**PLANNED UNIT DEVELOPMENT &
SIDEWALK WAIVER REQUEST
STAFF REPORT****Date: November 7, 2013****NAME**

Audubon Properties, LLC.

LOCATION4700 & 4960 Dauphin Island Parkway
West side of Dauphin Island Parkway, 580'± North of
Marina Drive North).**CITY COUNCIL
DISTRICT**

CONTEMPLATED USEPlanned Unit Development Approval to allow multiple
buildings on a single building site, and a Sidewalk Waiver
to waive construction of a sidewalk along Dauphin Island
Parkway.**TIME SCHEDULE
FOR DEVELOPMENT**

SITE PLAN

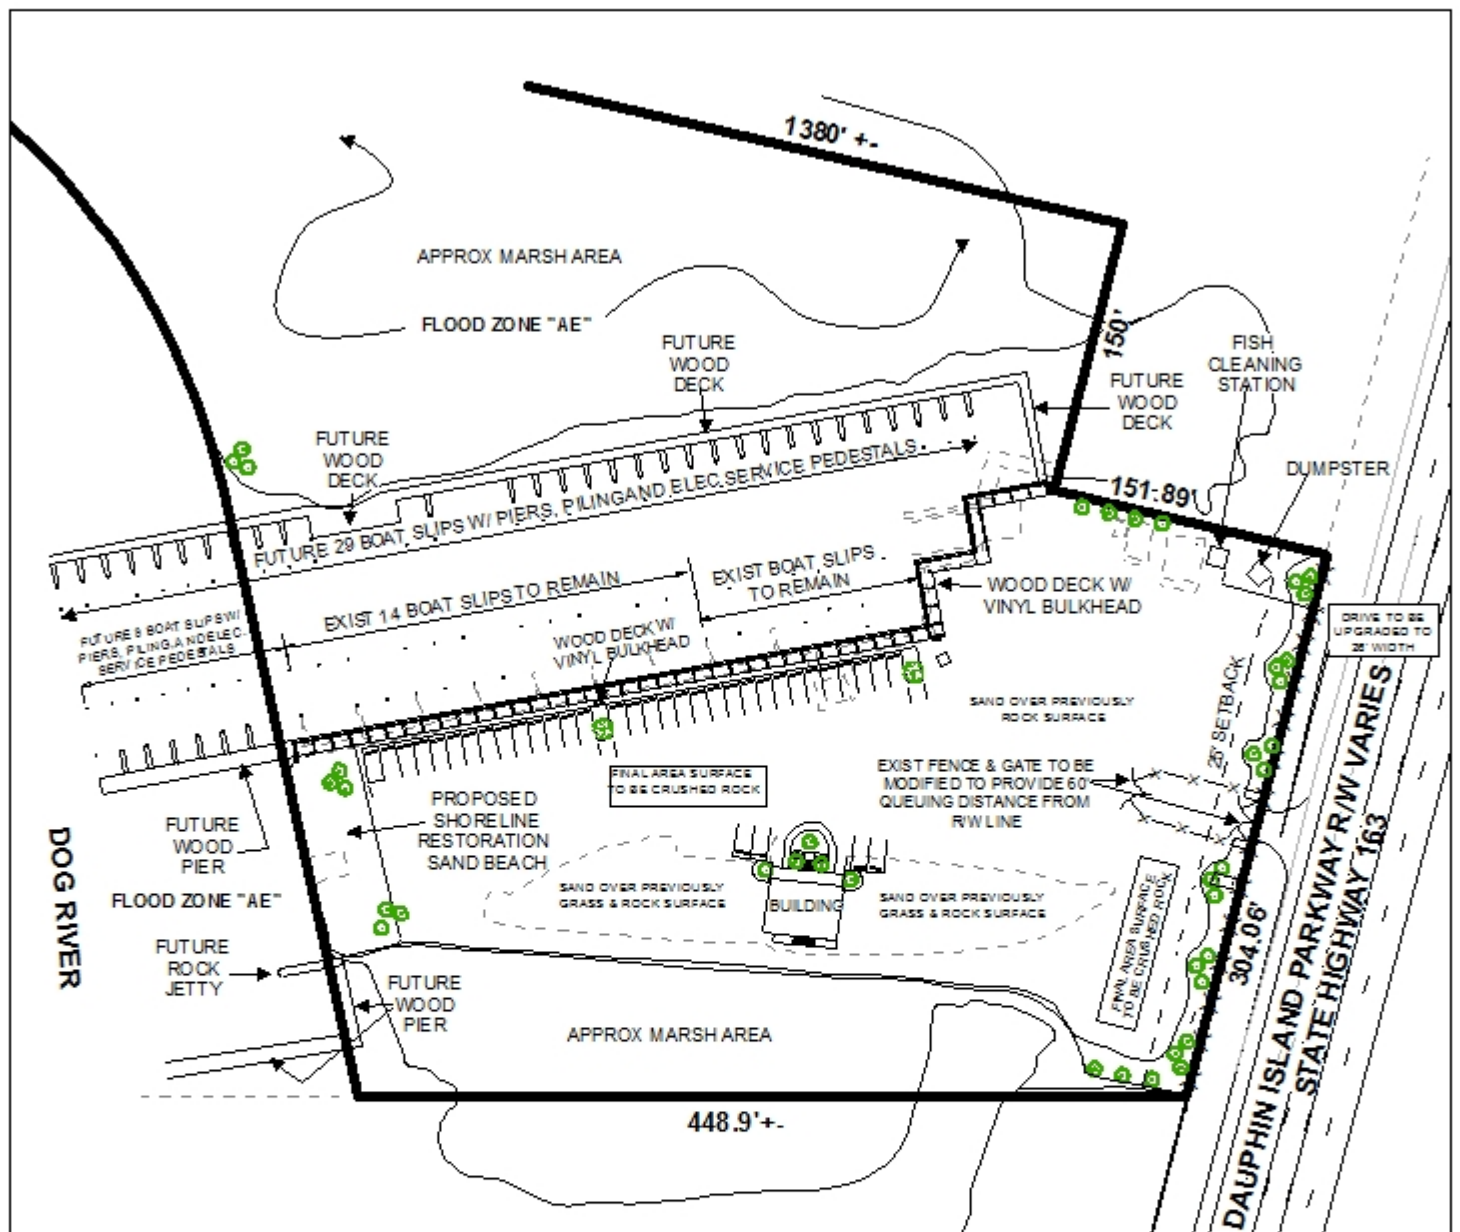
Driveway number, size, location and design to be approved by Traffic Engineering and ALDOT conform to AASHTO standards. The current pavement width of the driveway is approximately 16' at the gate opening. This width is substandard and should be upgraded. An ALDOT permit will be required for this work. There is approximately 30' between the edge of the travel lane and the gate. This is sufficient off-roadway storage for one vehicle to stop to open the gate, but only a vehicle, not a vehicle towing a boat. It appears that there will no longer be boat launching at this site, however boat storage is a possibility. There is an 8' paved shoulder along the edge of the roadway; it could be possible for a vehicle/trailer combination to pull out of the travel lanes without adversely affecting traffic. Aggregate surface will require parking spaces to be delineated with curb stops, as illustrated.

It appears, generally, that the number of parking spaces will be adequate for the proposed use and the site plan depicts each parking space with a wheel stop, however, there appear to be no accessible parking spaces shown on the plan. The applicant should verify if accessible parking will be required. If accessible parking is required, a revised site plan depicting the revised parking spaces will be required.

The site currently has an existing iron fence and gate that runs along the right-of-way frontage of Dauphin Island Parkway. The gate should be modified to provide a 60' queuing distance from

the right-of-way line. It appears the existing driveway is not 24' wide as required by the Zoning Ordinance, thus modifications should be made to address this issue. The labeling of the right-of-way width along Dauphin Island Parkway should also be illustrated on the site plan.

A screened enclosed dumpster is noted and depicted on the site plan. However, there is no indication that the dumpster will be connected to sanitary sewer. The site plan should be revised to indicate if the dumpster will be connected to sanitary sewer. All other notes displayed on the site plan should be retained on any revised plans.

Revised for the December 19th meeting: Driveway has been noted to be upgraded as approved by Traffic Engineering and ALDOT. Gate is noted to be relocated to provide adequate queuing from right-of-way. Handicap parking spaces, as required, must be of appropriate surface material to provide accessibility to the site amenities.

- 4) revision of the site plan to show the relocation of the existing gate to provide a 60' queuing distance from the right-of-way line;
- 5) labeling of right-of-way width of Dauphin Island Parkway on site plan;

- 6) revision of the site plan to indicate a driveway width of 24';
- 7) placement of a note on the site plan stating that approval of all applicable Federal, state and local agencies is required for endangered, threatened or otherwise protected species;

- 9) revision of the site plan to indicate the dumpster will be connected to sanitary sewer;
- 10) retention of all other existing notes on any revised plans;

DETAIL SITE PLAN

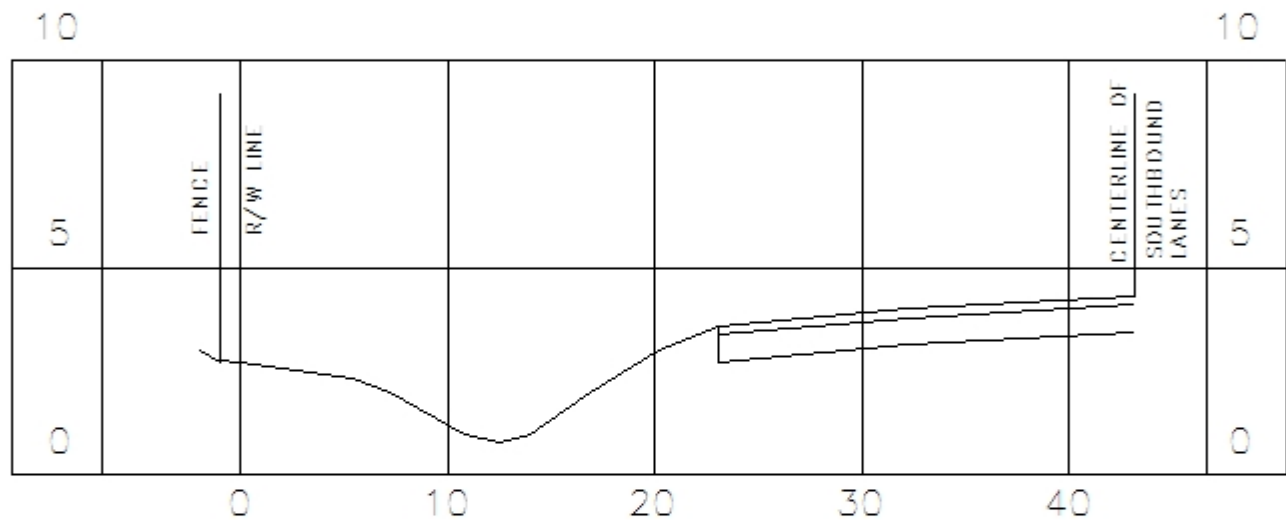
Sidewalk Waiver: Due to the location and the size of the existing roadside drainage ditch, a road edge without any curbing, and a site use that is not conducive to pedestrian traffic it is recommended that this request be approved.

Finally, the applicant is requesting a waiver of the sidewalk requirements for Dauphin Island Parkway. The applicant states that there are "*utilities above and below ground that exist along the West side of Dauphin Island Parkway.*" The applicant also states that power poles, guy wires, a sanitary sewer manhole, fire hydrant, and the existing storm water drainage ditch with side slopes limits space, which would make the construction of sidewalks along the West of Dauphin Island Parkway very difficult. The Engineering Department recommends approval of the sidewalk waiver due to various issues with the tight-of-way.
